Submissions on Plan Change 8 (Natural Hazards) Volume 1

SUBMISSION ON PLAN CHANGE 8 (NATURAL HAZARDS) - LAKES A ZONE

Figure 1. Pluvial Flooding shown utilising topographic data from RLC Plan Change 8 website.

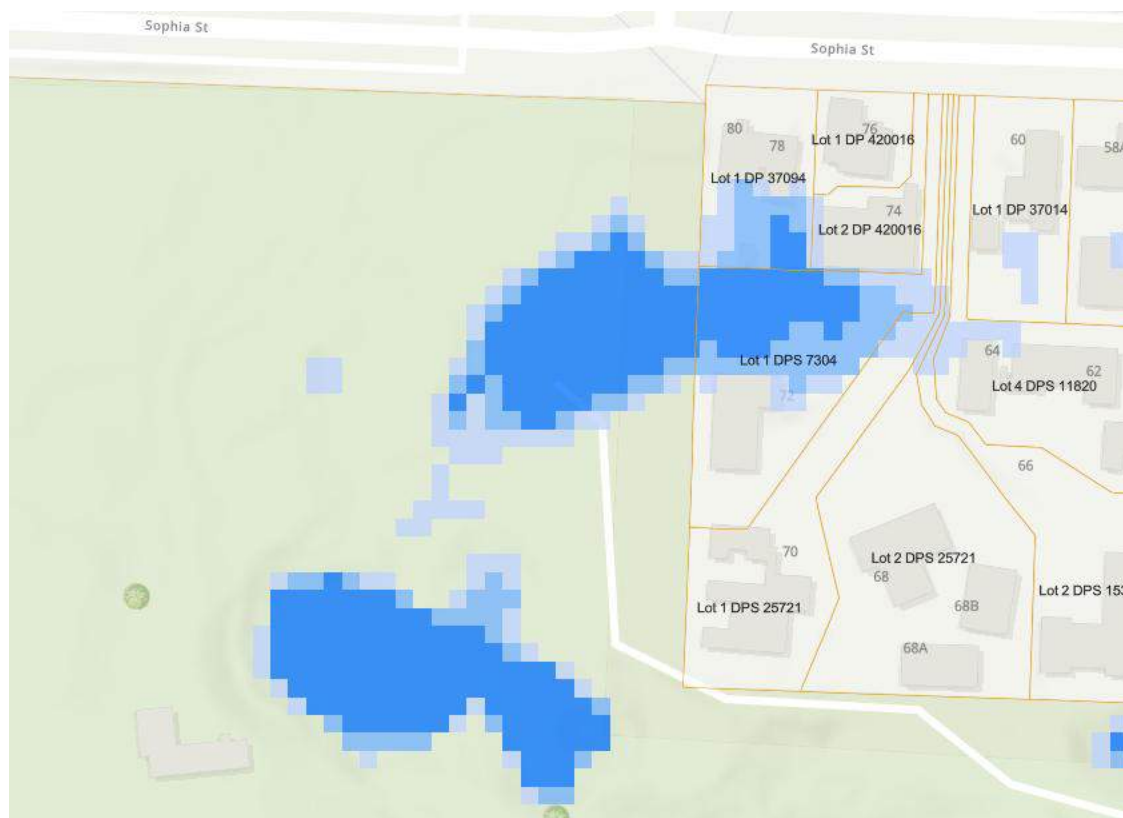
The subject of this submission is the pluvial flooding hazard layer recently applied to the property as part of the Council's Western Catchment Flood Hazard Mapping initiative. This hazard layer, as depicted in the Council's public-facing GIS system, indicates a significant portion of the property, as seen below in Figure 1., is subject to inundation in a 1% Annual Exceedance Probability (AEP) storm event, projected for a 2100/2130 climate change scenario (IPCC RCP 8.5).

The property owners formally request that the Rotorua Lakes Council (the Council) take immediate action to completely and permanently remove the aforementioned pluvial flooding hazard layer from the property at 72 Sophia Street (Lot 1 DPS 7304). This removal should be reflected in all Council planning maps, GIS databases, and any associated records used for the generation of Land Information Memorandum (LIM) reports.

Figure 3. Plan view broadly showing existing stormwater controls unaccounted for in Council Pluvial Flood Report

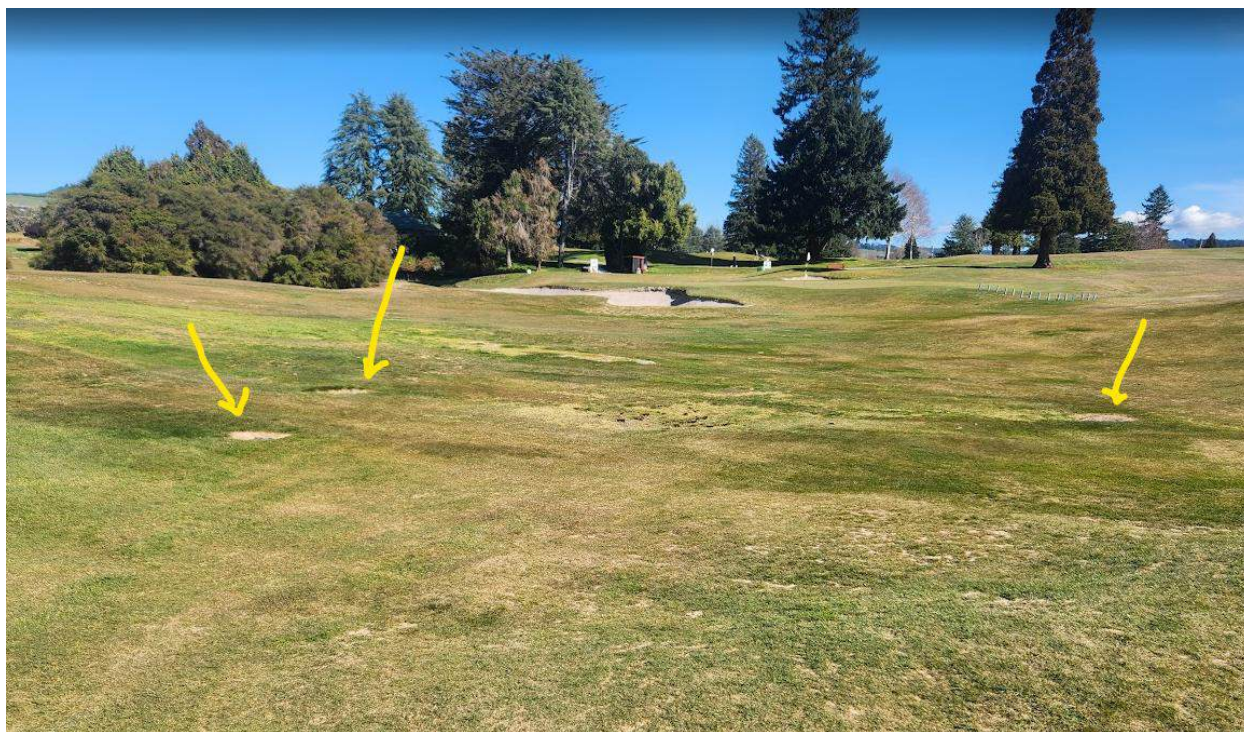
Course, and its drainage is influenced by multiple cesspits and stormwater drain located on the golf course, which are not part of the Council's network and are therefore not included in the model. This introduces a further, un-quantified error into the model's simulation for this specific location. Figure 3 shows a broad plan of stormwater infrastructure. Figures 4, 5 and 6 below show the location of this infrastructure.

Figure 3. Updated 2025 GNS Mapping showing a newly identified fault trace and Fault Avoidance Zone crossing Red Stag's land.

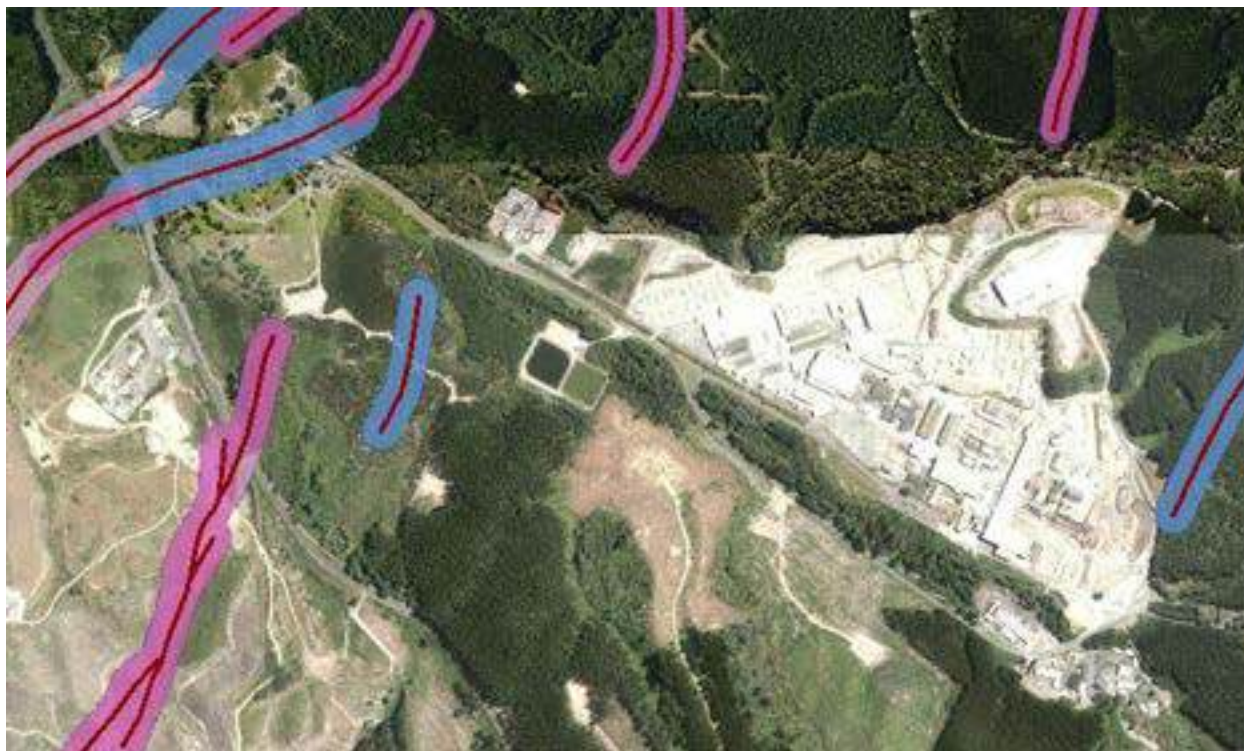
In stark contrast, the newly proposed framework is based on the GNS Science Consultancy Report 2025/02 LR, which utilizes updated high-resolution LiDAR data.¹ This new assessment has resulted in the mapping of a fault trace directly across the Submitter's property, as shown in Figure 3.

This is not a minor cartographic adjustment; it is a profound re-characterisation of the land. It triggers the application of a new and significant regulatory regime under the proposed 'Fault Rupture Hazard Area' provisions in PC8, where previously none existed. This change, originating from a desktop study, has both immediate and material consequences for all future development, investment, and site management.
